MONTICELLO NUCLEAR GENERATING PLANT

ITS Section 3.7,
Plant Systems

MONTICELLO
IMPROVED TECHNICAL
SPECIFICATIONS CONVERSION

**ITS 3.7.1, Residual Heat Removal Service Water (RHRSW)
System**

**Current Technical Specification (CTS) Markup
and Discussion of Changes (DOCs)**

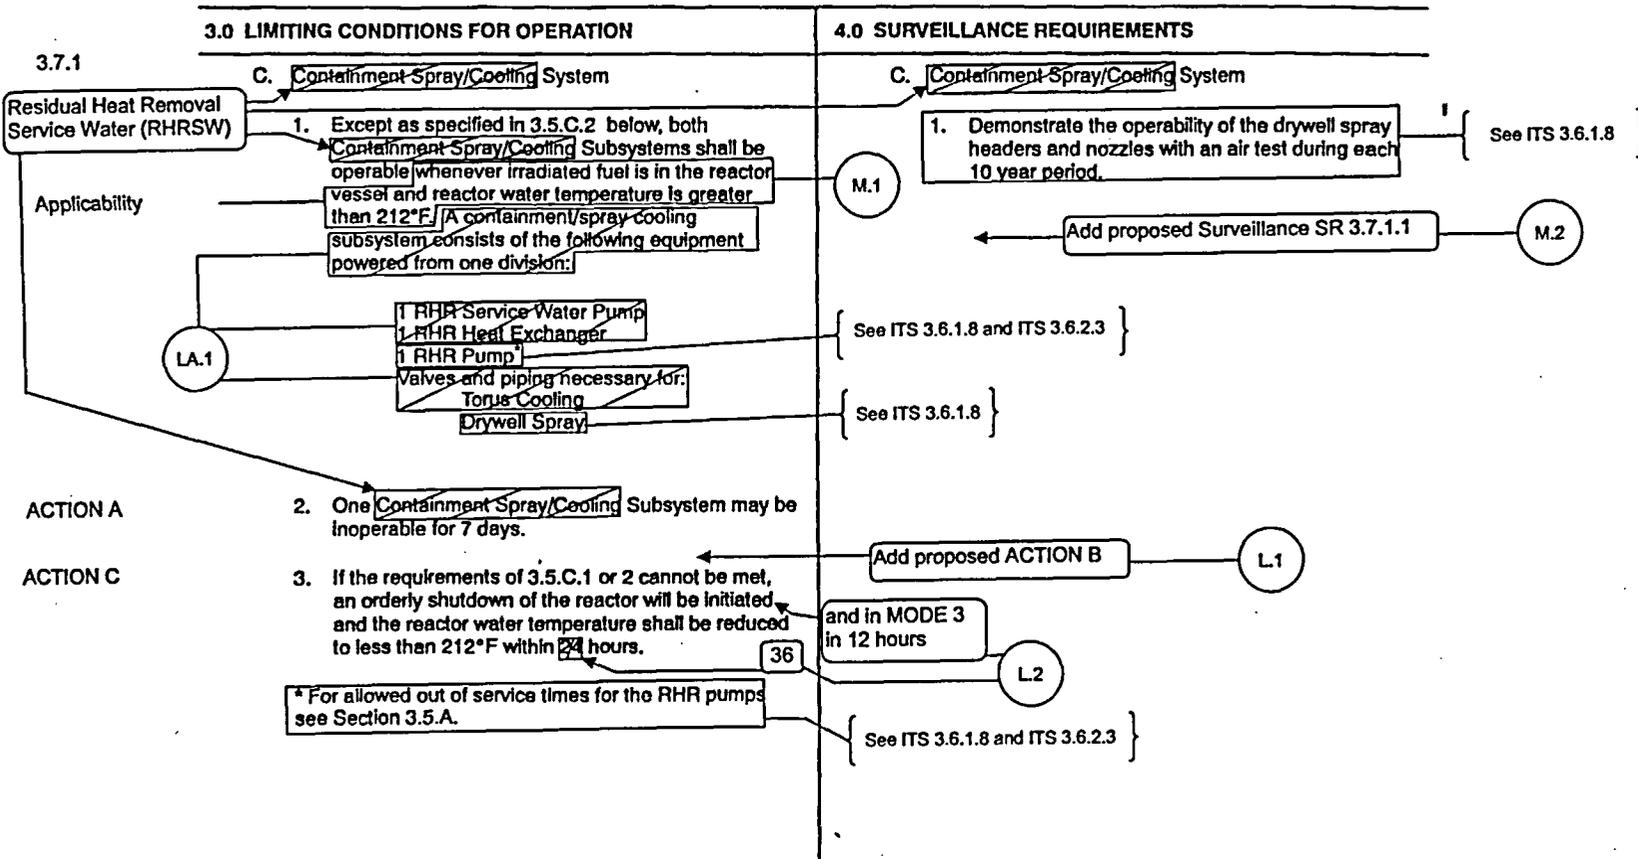
- M.1 CTS 3.5.C.1 is applicable whenever irradiated fuel is in the reactor vessel and reactor water temperature is greater than 212°F. ITS LCO 3.7.1 is applicable in MODES 1, 2, and 3. This changes the CTS by requiring two RHRSW subsystems to be OPERABLE in MODE 2 when reactor water temperature is less than or equal to 212°F.

- M.2 Currently, the CTS does not provide any specific Surveillances to verify OPERABILITY of the RHRSW subsystems. ITS SR 3.7.1.1 requires verification that each RHRSW subsystem manual, power operated, and automatic valve in the flow path that is not locked, sealed, or otherwise secured in position is in the correct position or can be aligned to the correct position every 31 days. This changes the CTS by adding this Surveillance Requirement to the Technical Specifications.

3.17/4.17

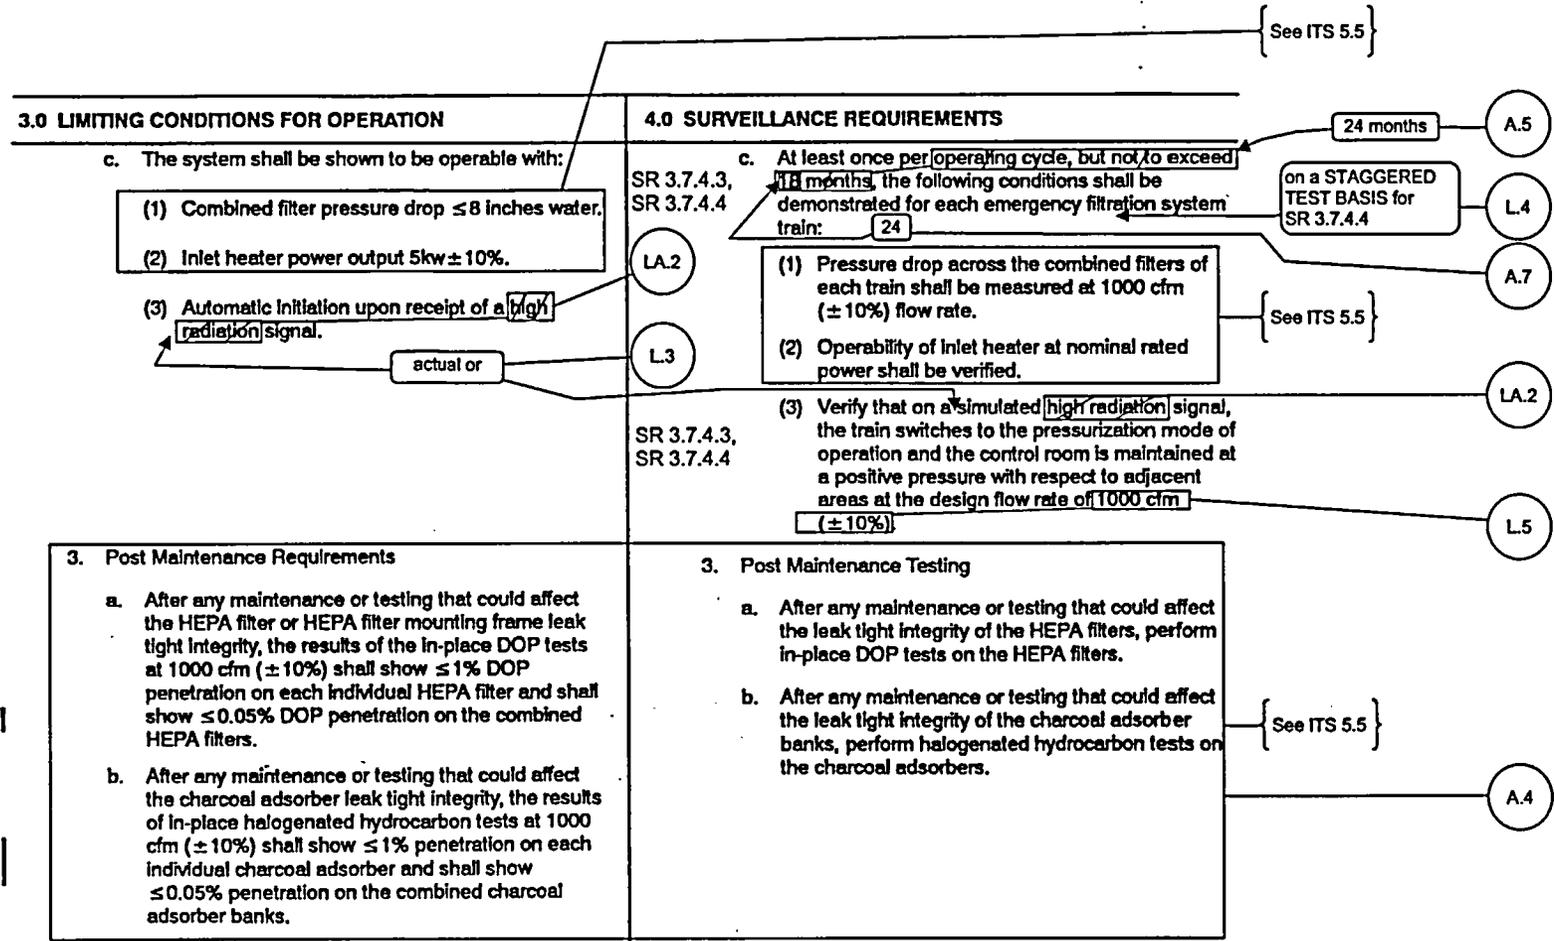
- A.3 Under certain conditions, CTS 3.17.B.1.c and 3.17.B.1.d, in part, require the immediate suspension of movement of recently irradiated fuel assemblies in the secondary containment. ITS 3.7.4 ACTIONS D and F include the same requirement, however a Note has been added that states that LCO 3.0.3 is not applicable. This changes the CTS by adding this Note.

This change is acceptable because filter testing requirements are being moved to the VFTP as part of ITS 5.5 and ITS SR 3.7.4.2 references the VFTP for performing these tests. This change is designated as administrative because it does not result in technical changes to the CTS.

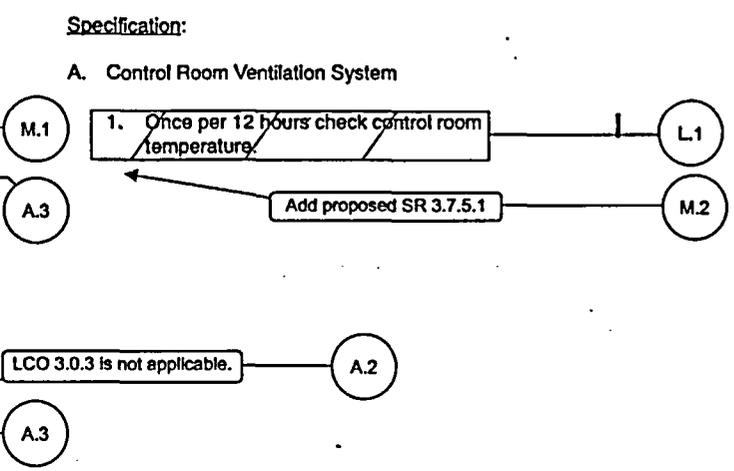
- 3.7.5 A. Control Room Ventilation System
- LCO 3.7.5 1. Except as specified in 3.17.A.2 and 3.17.A.3 below, both trains of the control room ventilation system shall be operable whenever irradiated fuel is in the reactor vessel and reactor coolant temperature is greater than 212°F or during movement of irradiated fuel assemblies in the secondary containment, core alterations or activities having the potential for draining the reactor vessel.

- Applicability
- ACTION A 2.a With one control room ventilation train inoperable, restore the inoperable train to operable status within 30 days.
- ACTION B 2.b If 2.a is not met, then be in hot shutdown within the next 12 hours following the 30 days and in cold shutdown within 24 hours following the 12 hours.
